PRELIMINARY SITE GRADING CONSTRUCTION PLANS
FOR
HILLSIDE AT LORSON RANCH
EARLY OVERLOT GRADING / EROSION CONTROL PLANS

PROJECT:
HILLSIDE AT LORSON RANCH
LORSON BLVD AND WALLEYE DR
COLORADO SPRINGS, COLORADO

**COVER SHEET
EARLY GRADING AND
EROSION CONTROL PLAN**

**POND E1
POND FOREBAY DETAILS**

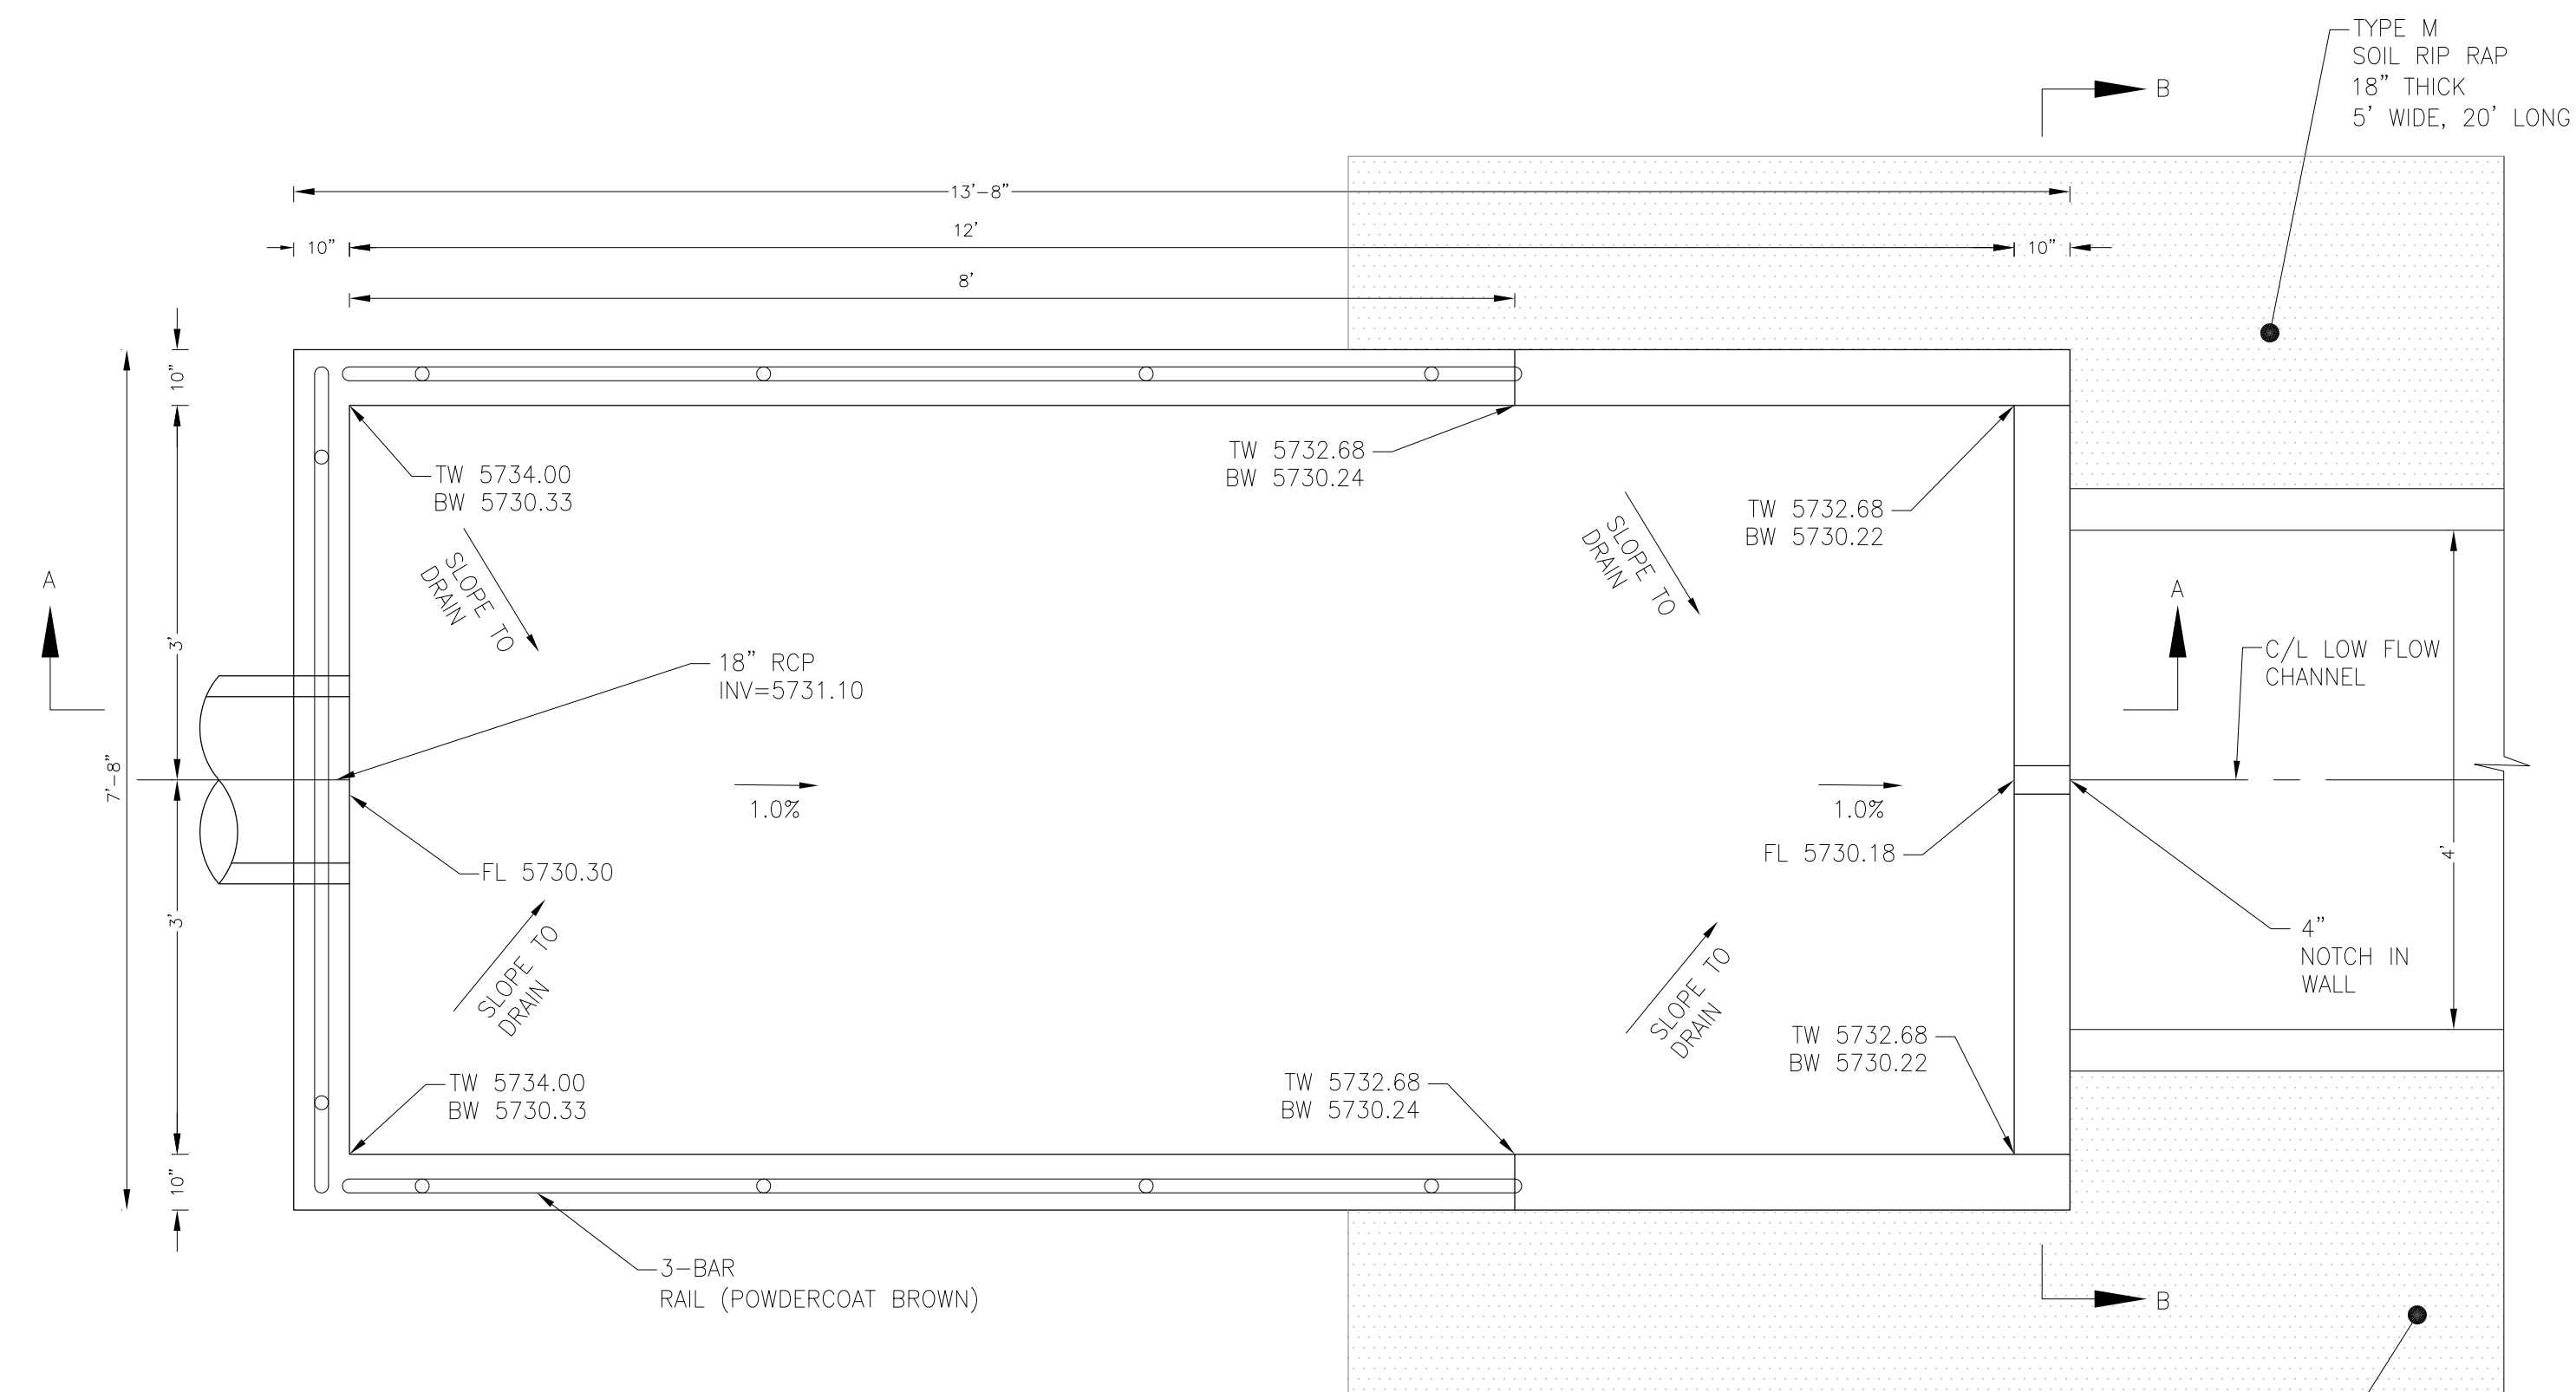
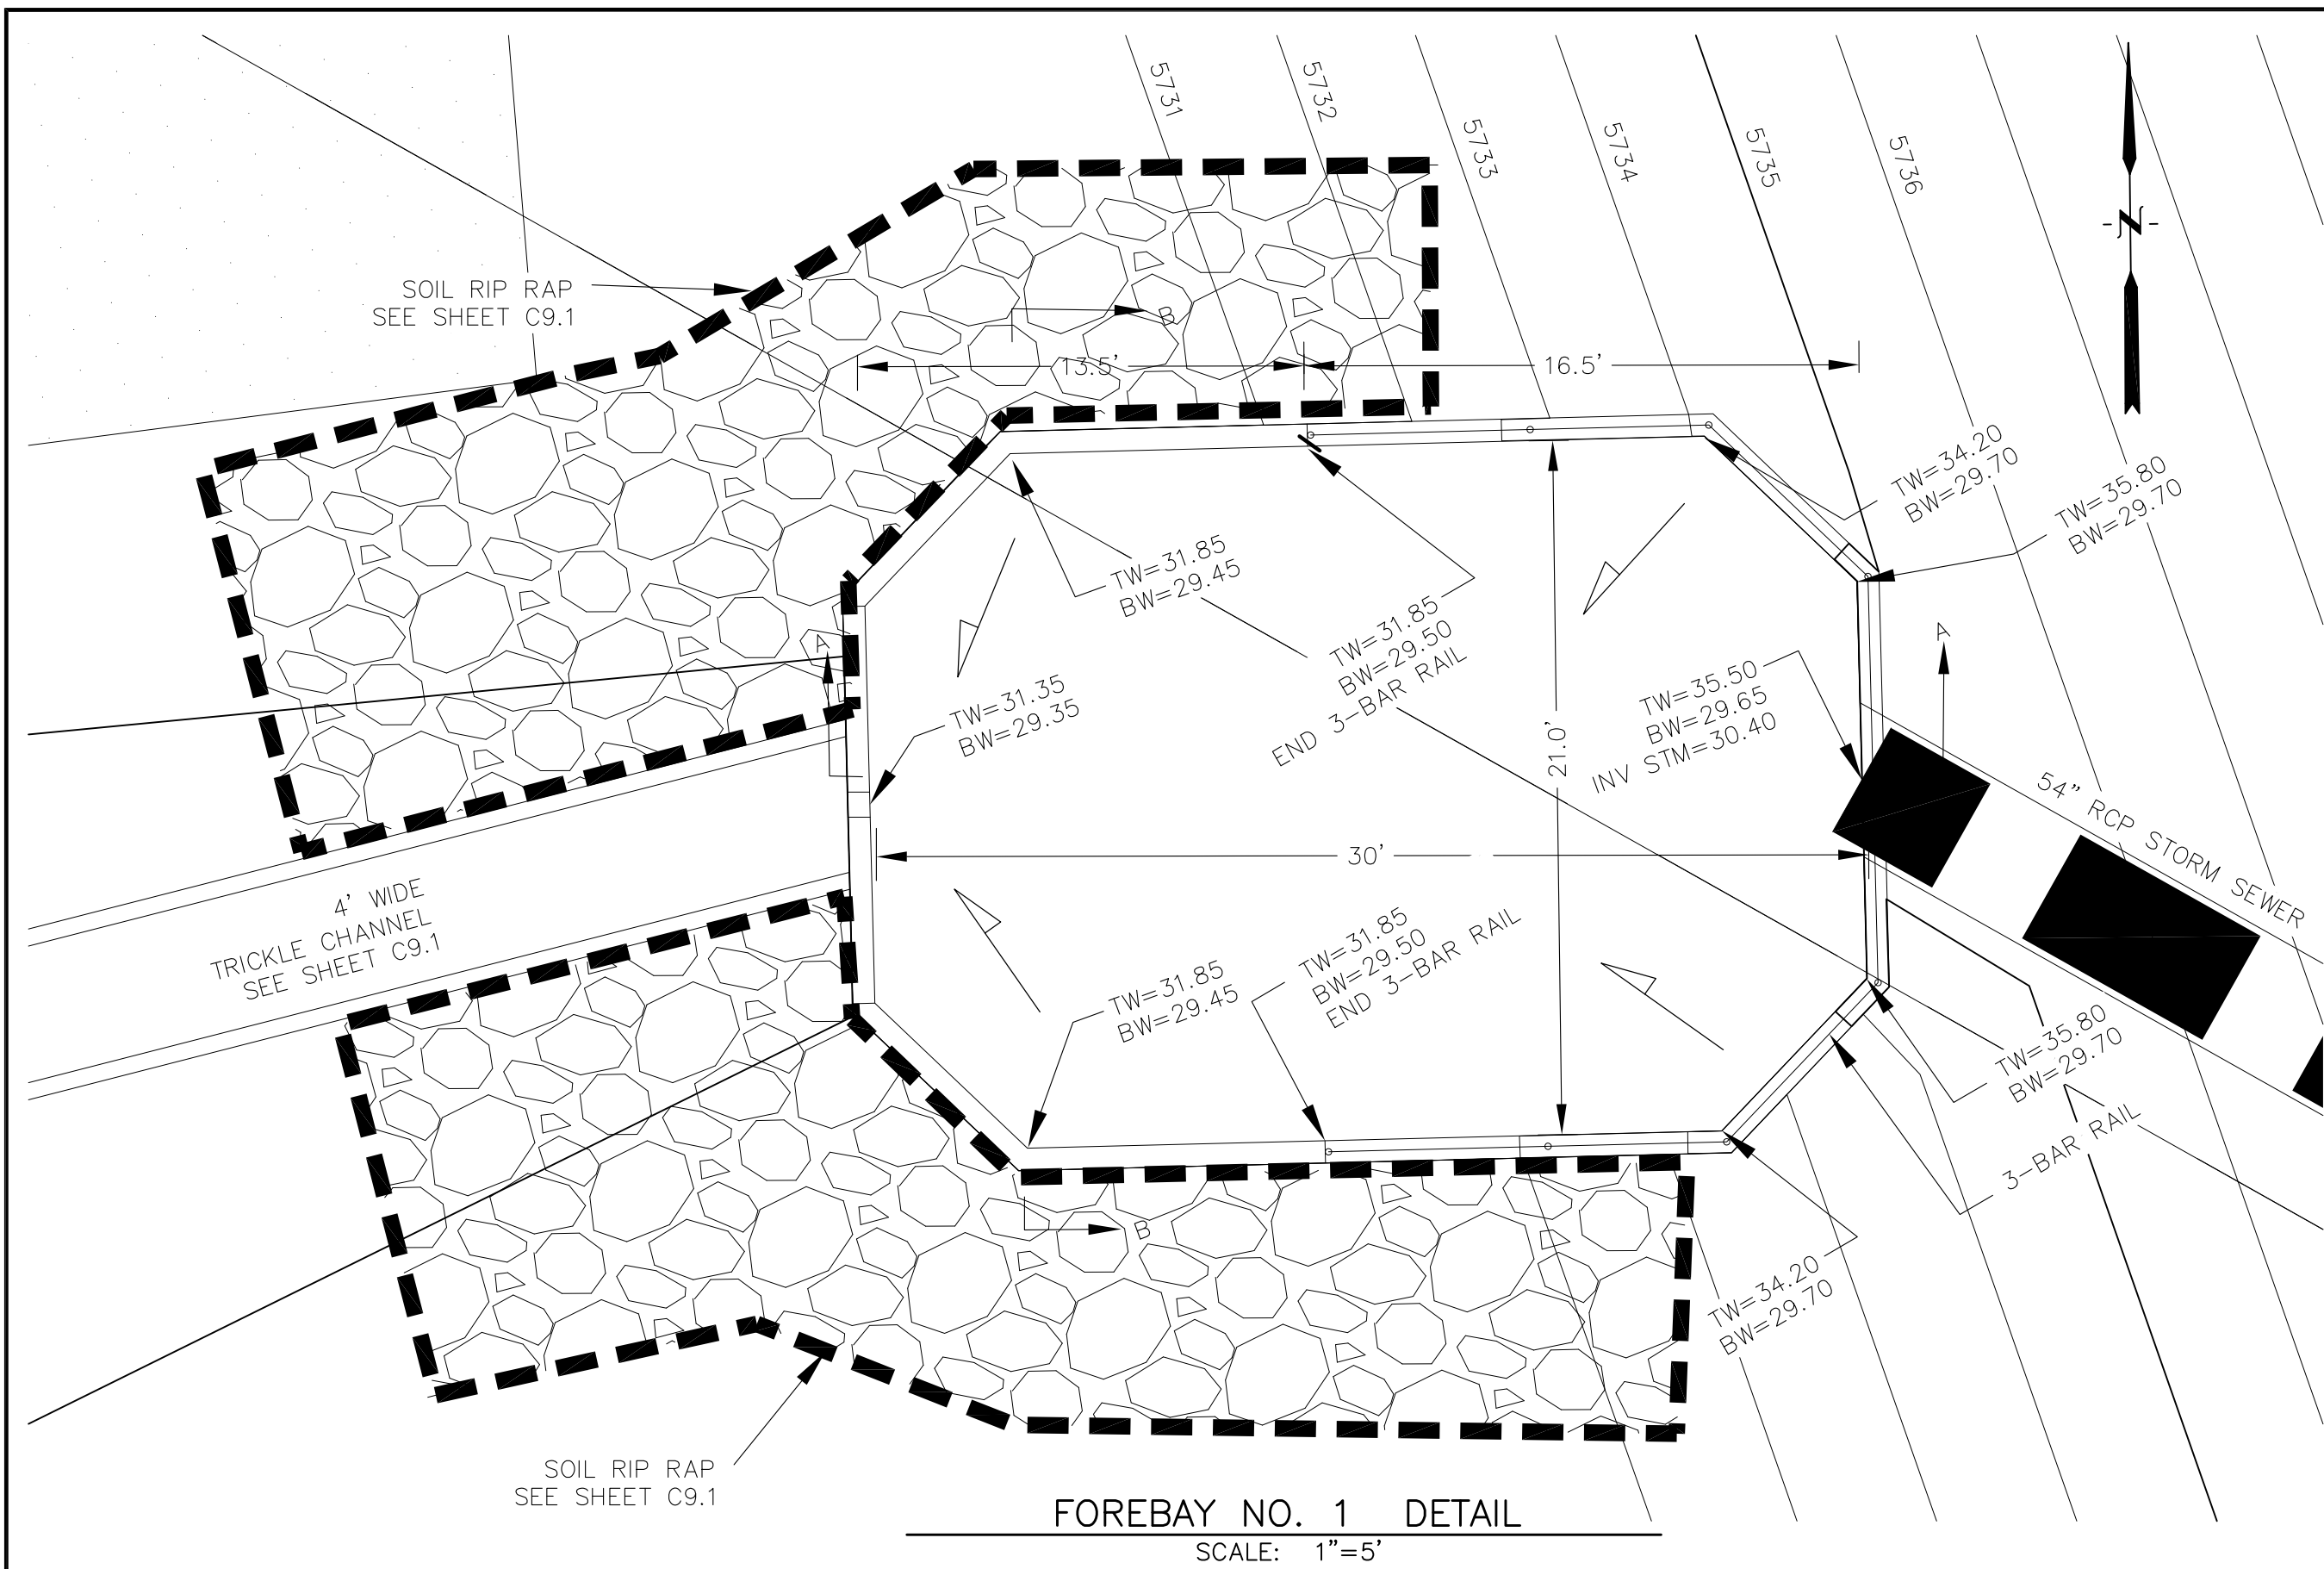
does not match what is shown on pdf pg 122 of PDR. Revise to remove discrepancy.
